Project
**Conversion
Store Twenty One
56 High Street Bognor**

Drawing
Proposed Roof Plan

Job Number Drawing Number : Revision
4547 08: A

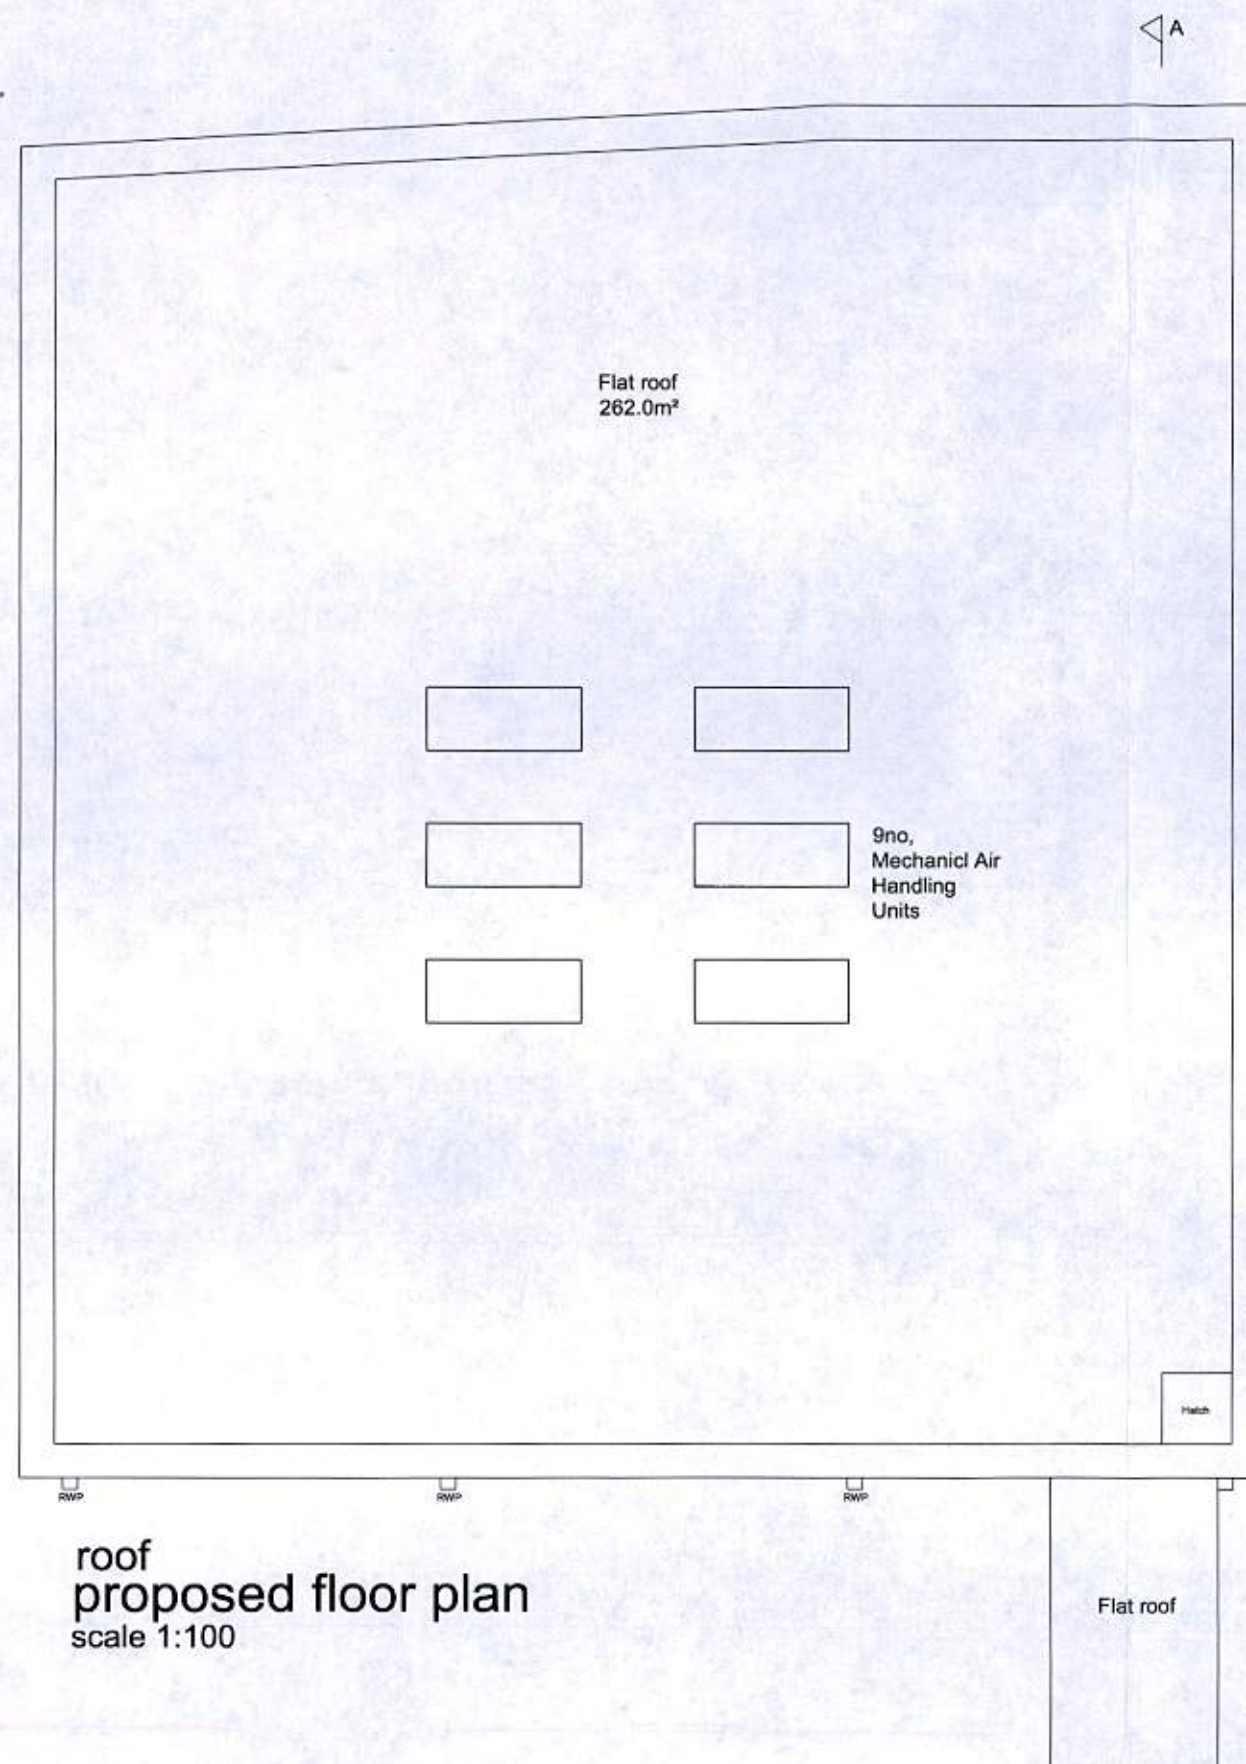
A. Stair plan revised to suit M&E electrical cupboard
New cat ladder added
